Point Beach Nuclear Plant, Units 1 and 2  
Dockets 50-266 and 50-301  
Renewed License Nos. DPR-24 and DPR-27

License Amendment Request 261  
Extended Power Uprate  
Clarification of Response to Request for Additional Information

#### LICENSE AMENDMENT REQUEST 261 EXTENDED POWER UPRATE CLARIFICATION OF RESPONSE TO REQUEST FOR ADDITIONAL INFORMATION

**MOTOR DRIVEN AND TURBINE DRIVEN AUXILIARY FEEDWATER  
SUCTION PRESSURE TRANSFER AND PUMP TRIP TIMING**

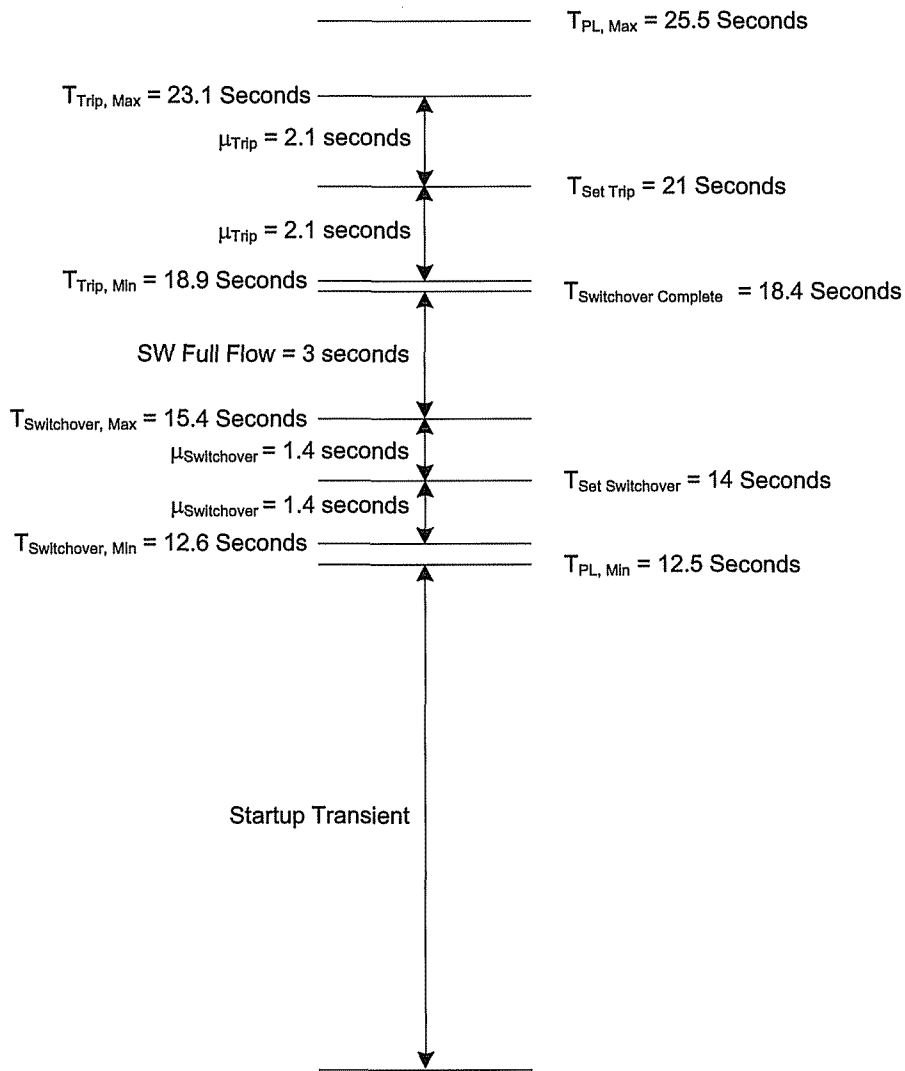
Provide Time response values and the specific design criteria for Figure 2 provided in NextEra Energy Point Beach, LLC letter to NRC, dated November 21, 2009, License Amendment Request 261 Extended Power Uprate Response to Request for Additional Information.

Time response values and specific design criteria for the motor driven and turbine driven auxiliary feedwater pump suction pressure transfer and pump trip is provided in Enclosure 2.

Time  $T = 0$  occurs when the low suction pressure is sensed. The Analytical Limit for the low suction pressure is based on the elevation required to ensure that sufficient water (including water pumped during the associated switchover and trip time delays) is available to supply the AFW Pumps until they automatically switchover/trip, thus preventing damage to the pump .

$T_{PL, Max}$  is the maximum allowable time delay for the pump trip.
